## **SECTION 4.56 APPLICATION TO MODIFY DA-826/2020 | 149-163 MILTON STREET, ASHBURY**

This letter has been prepared by Urbis Ltd on behalf of Coronation Property (the Applicant) in support of a section 4.56 application to modify DA-826/2020 pertaining to land at 149-163 Milton Street, Ashbury (the site).

Figure 3 Proposed OC Staging Plan – Basement and Ground Level (Stage 1 shown in blue and Stage 2 shown in green)

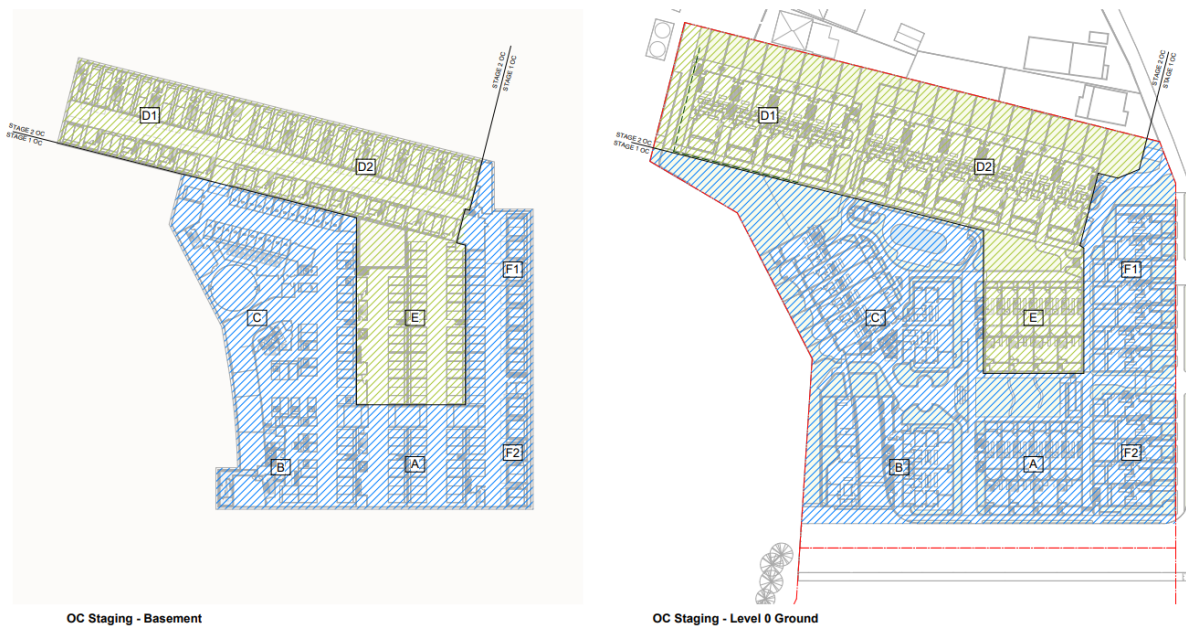
- Staging of the conditions of consent to enable the approved development to be delivered in stages. The staging is described below and shown in **Figure 3**.
  - Stage 1: Part Basement and Buildings A, B, C, F1 & F2.
  - Stage 2: Part Basement and Buildings D1, D2 & E.

Figure 4 Approved and Proposed Basement Floor Plan

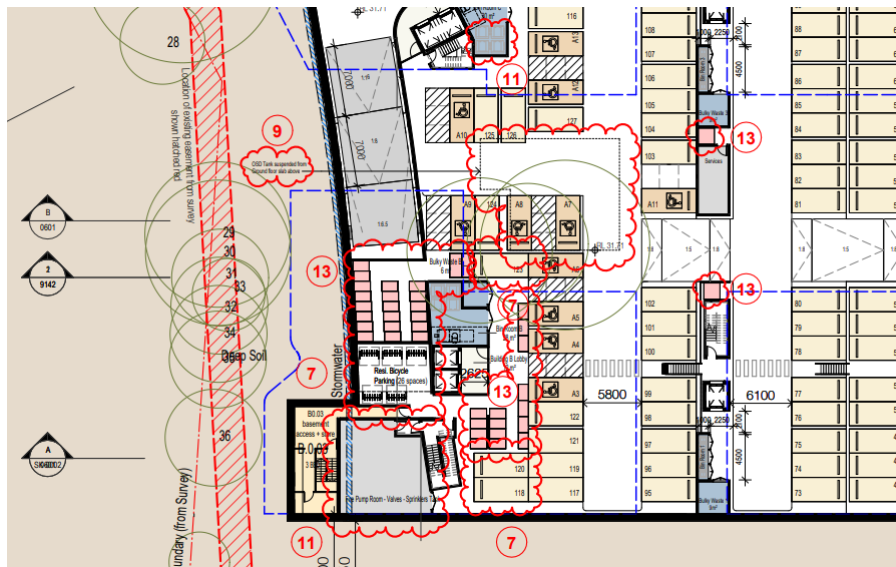
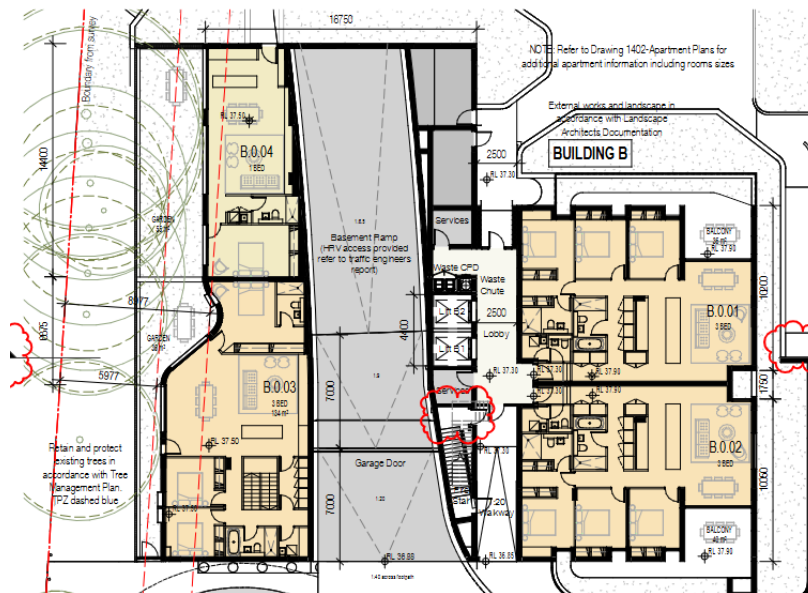
- Replacement of excess storage cages within the basement, with a communal gym which can be accessed from the Building B lift. Residential bicycle parking has also been relocated to accommodate the proposed location of the gym. The proposed development will continue to comply with requirements for residential storage under the Apartment Design Guide and bicycle parking provision under the Canterbury-Bankstown DCP.

Picture 2 Proposed basement floor plan showing location of gym and relocation of bicycle parking

Figure 5 Approved and Proposed Building B Ground Floor Plan

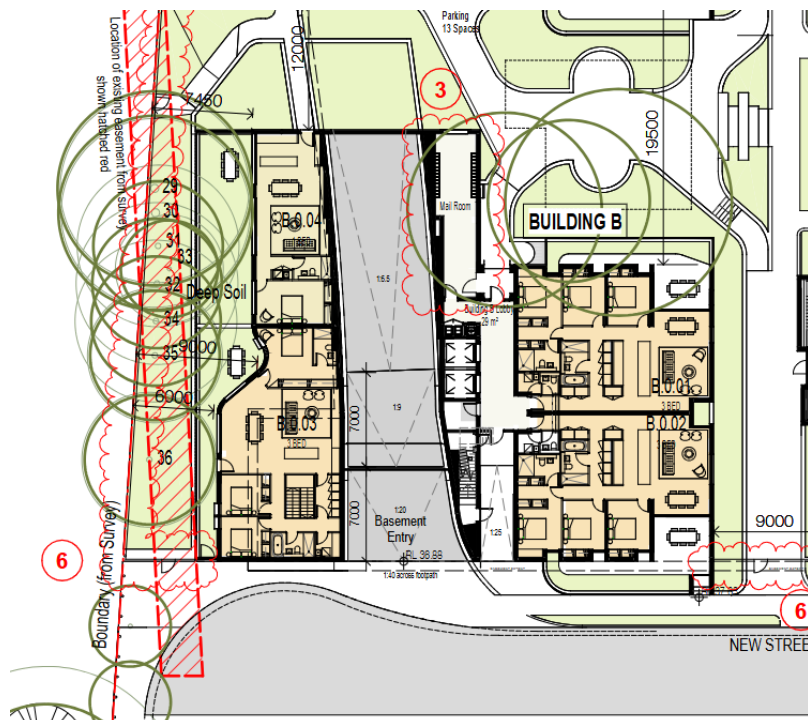
- Addition of a mail room to the ground floor of Building B and associated opening to Building B façade. This will provide for a consolidated location for mail and parcel collection to service the entire development. Access to the mail room will be provided internally from the Building B lobby. Currently the approved development does not contain a mail room, and this is essential to the orderly operation of the site.

Picture 4 Proposed Building B Ground Floor Plan shown proposed mail room

Figure 6 Approved and Proposed Northern Elevation

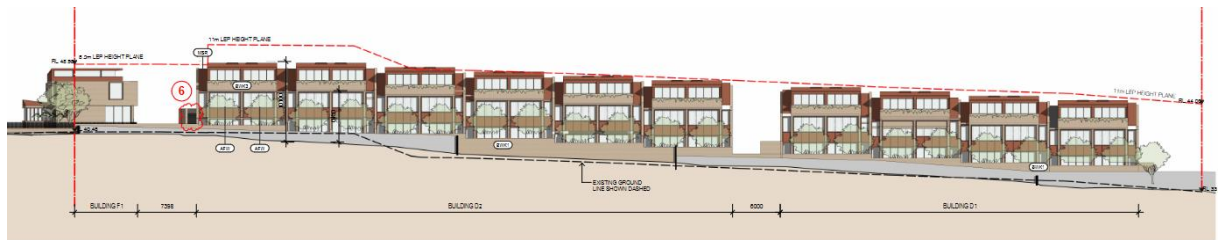
- Update to design and materiality of fence along northern and western site boundaries.

Picture 6 Proposed northern elevation showing proposed boundary fence

Figure 7 Approved and Proposed Building A and E Rooftop Design

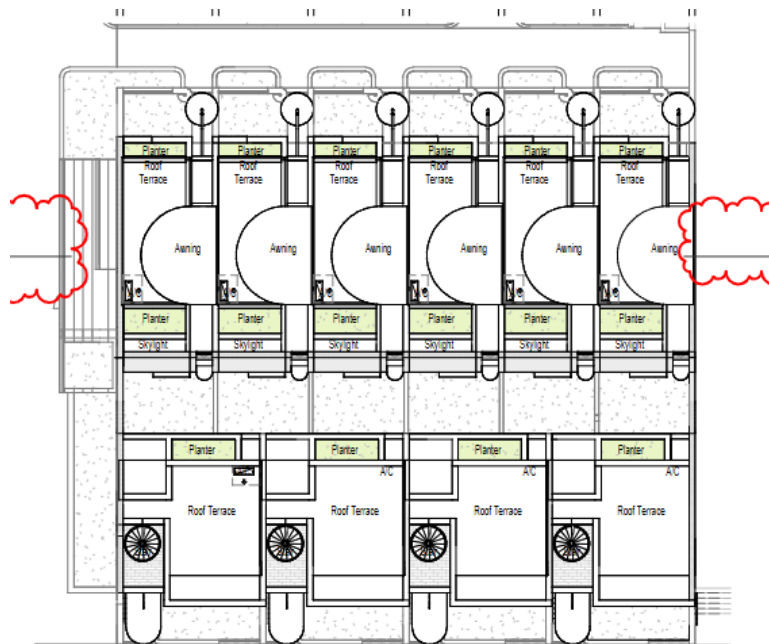
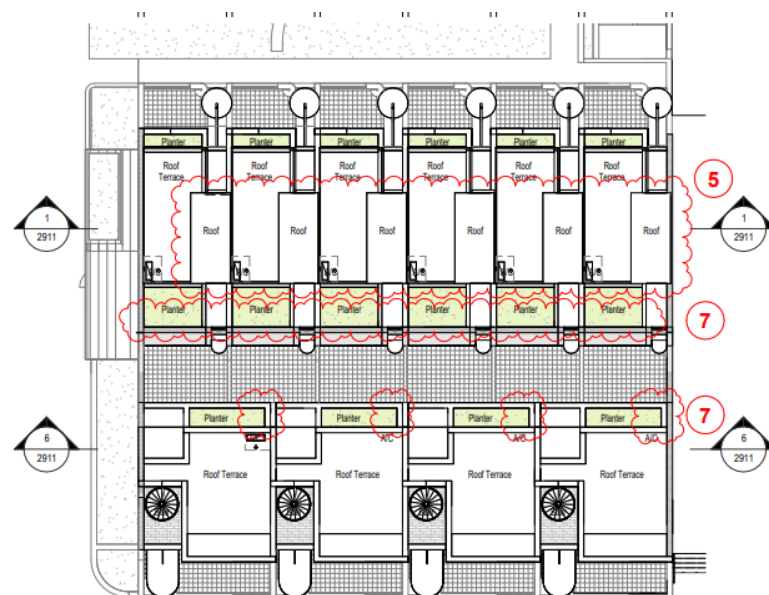
- Removal of skylights to Buildings A, D1, D2 and E.
- Refinement of the rooftop awning design of Buildings A and E to simplify construction. The revised roof design continues to provide weather protection to the door opening and will not result in an increase in height.

Picture 8 Proposed Building A and E rooftop design, including removal of skylights and awning redesign.

Figure 8 Extract of Approved and Proposed Ground Floor Landscape Plans

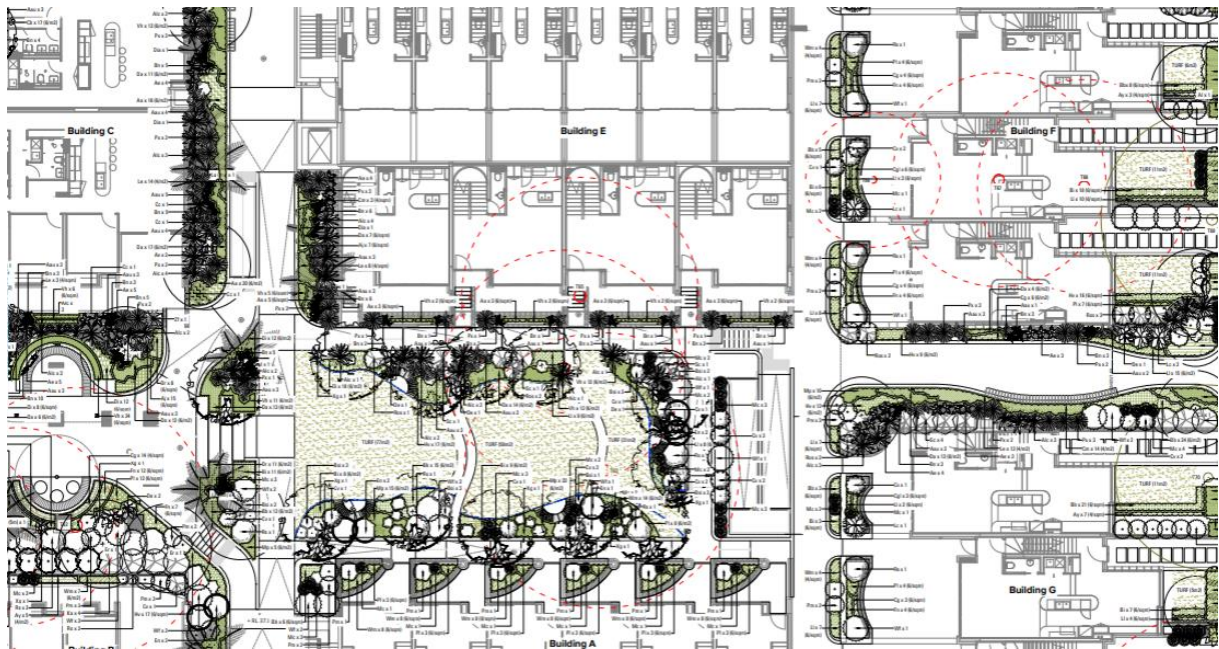
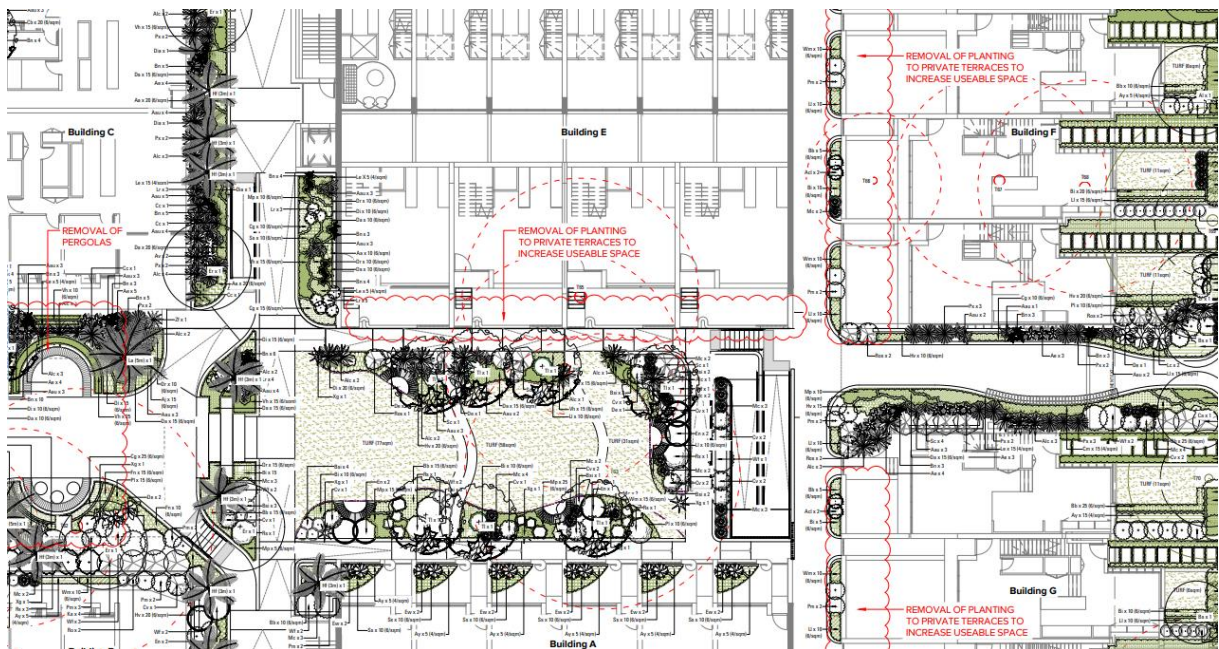
- Removal of planter boxes within ground level private terrace courtyards in Buildings A, D, E and F to increase the usable space of the courtyards for activities. This change has been made in response to purchaser feedback from the adjoining development at 165 Milton Street, Ashbury which established that the preference of purchasers was for the courtyard to contain more usable space.

Picture 10 Extract of proposed ground floor landscape plan showing proposed removal of planter boxes to private terrace courtyards.

Figure 9 Approved and Proposed Building B Communal Open Space Landscape Design

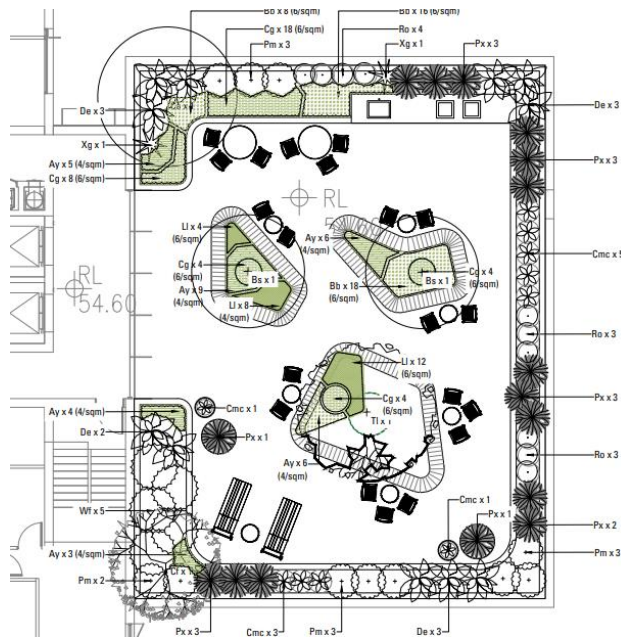
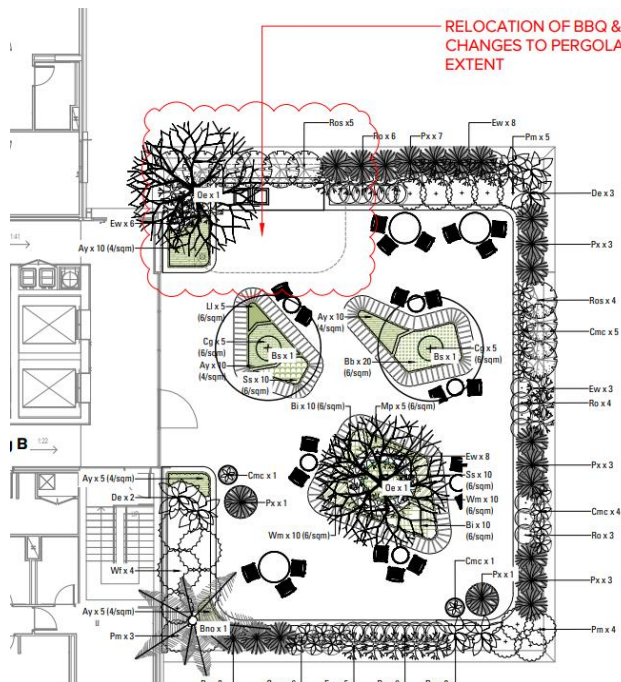
- Amendment to the design and layout of amenities of Building B rooftop communal open space.
- Reduction in extent of planter bed to Building C rooftop communal open space to increase useable space.
